< BEIJING MADV TECHNOLOGY CO., LTD >

Declaration of Product Modifications

This is to request a Class II permissive change for FCC ID: 2AJ2LFJ27HWXJ originally granted on 11/05/2023.

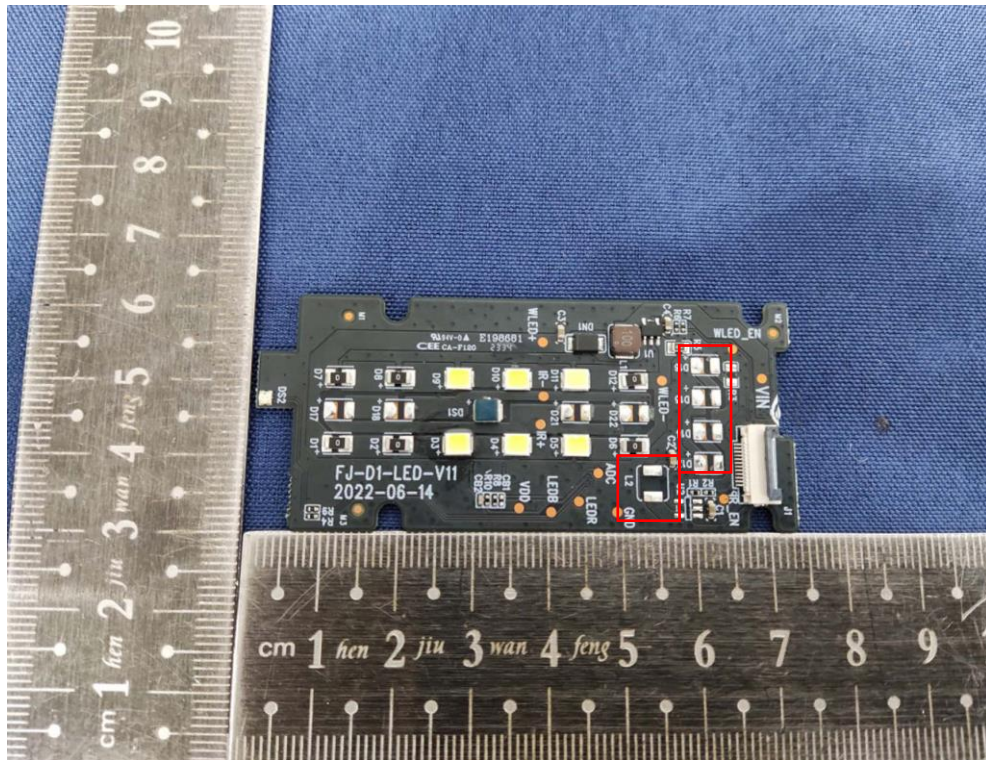
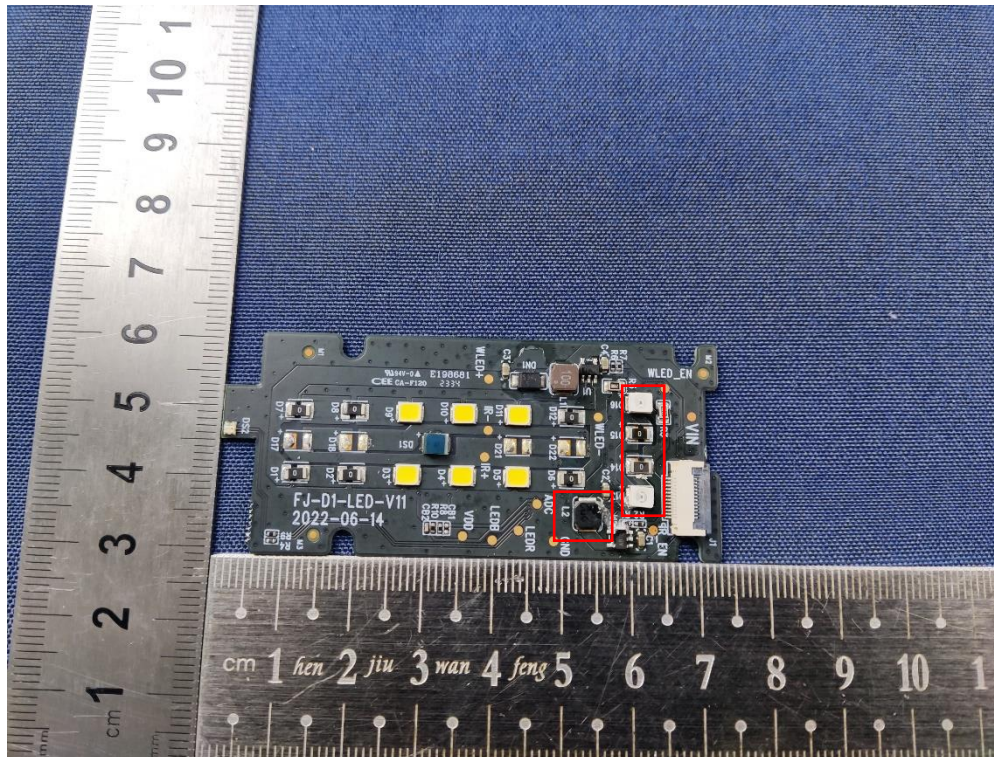
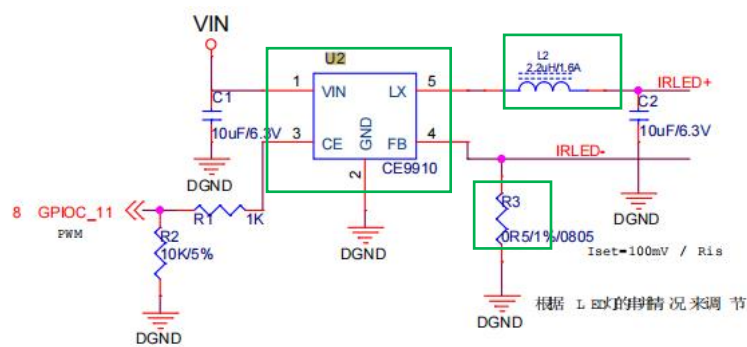
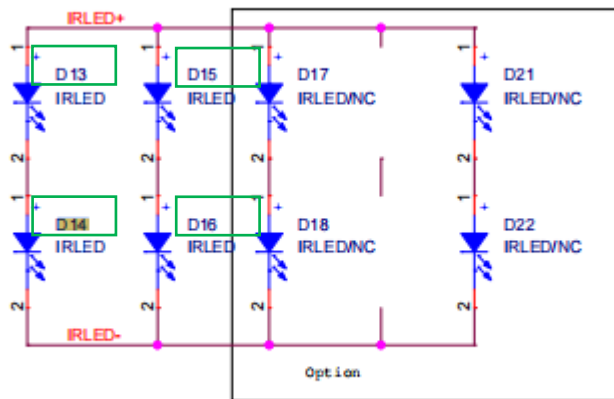
Change #1: Add D13, D16 1310001-0120-0 IR LED XYZ-IRP3528AC-X4/850nm/120*/H1.9mm/2.8*3.5mm

#2: Add D14, D15 chip resistor 0Ω-1206-1/8WY ±5%

#3: Add R3 1303003-0056-0 chip resistor 0.2Ω-0805-1/8W/ ±1%

#4: Add U2 1302011-0251-0 LED driver IC LED-Input 2.5V~6V-1A/CE9910/SOT-23-5/(chippower)

#5: Add L2 1305002-0170-0 power inductor MPLA4012-2R2M-LF/2.2uH+20%/DCR=0.1Ω-2.7A/4012/, substitute material 1305001-0164-0 power inductor WPN4012H2R2MT/SUNLORD Brand

These changes do not affect the RF emission function.
